XLAUI/CAUI Jitter Tolerance Test Requirement Proposal

**IEEE802.3ba
8 to 15 November 2008**

Toshihiro SUZUKI - Anritsu Corporation

83A.4.3.2 Jitter tolerance

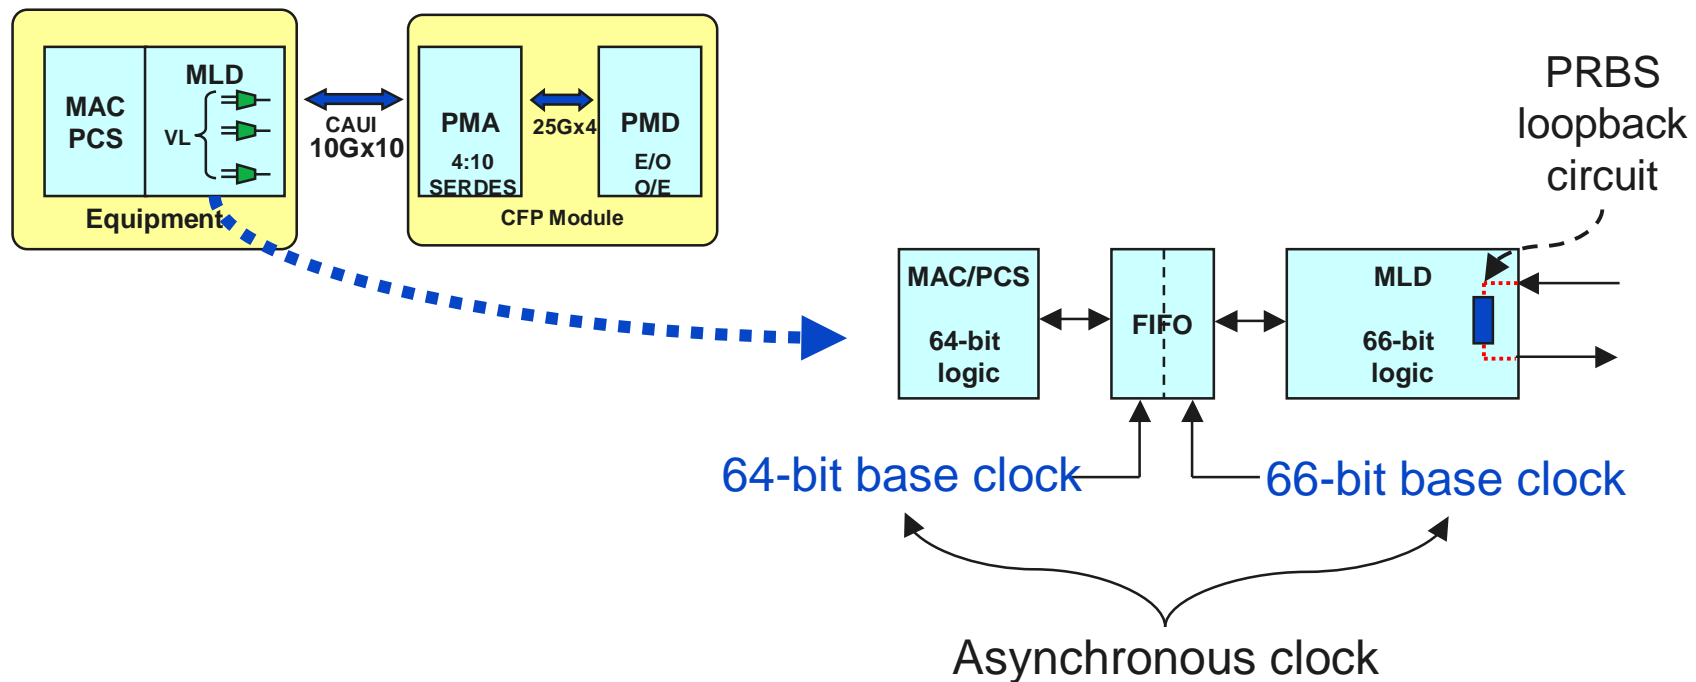
- This presentation proposes a test pattern for the Jitter test requirement in 83A.4.3.2 IEEE802.3ba D1.0.
- Testing should be under the worst conditions to achieve good product reliability.

Jitter Tolerance Test Pattern

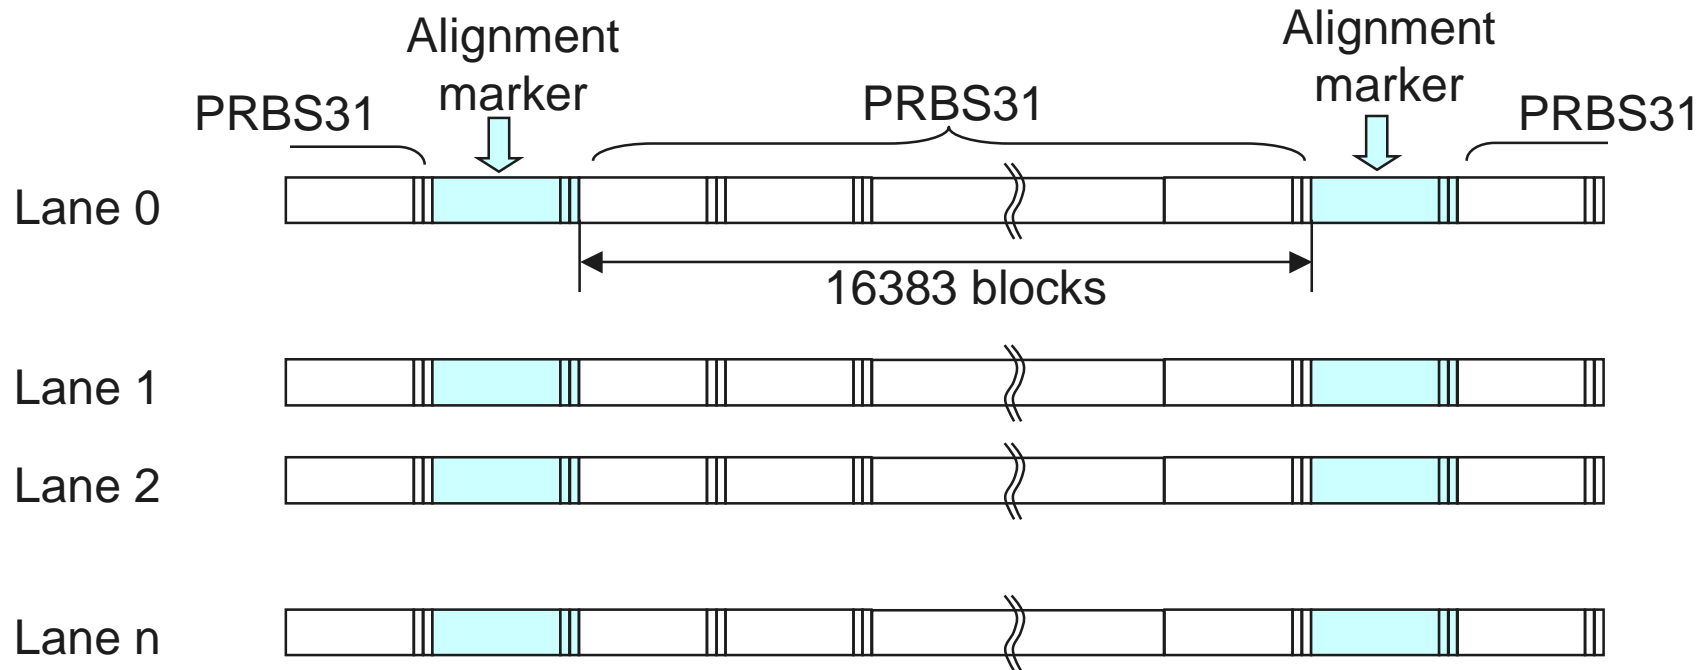
Test Jitter tolerance under worst condition
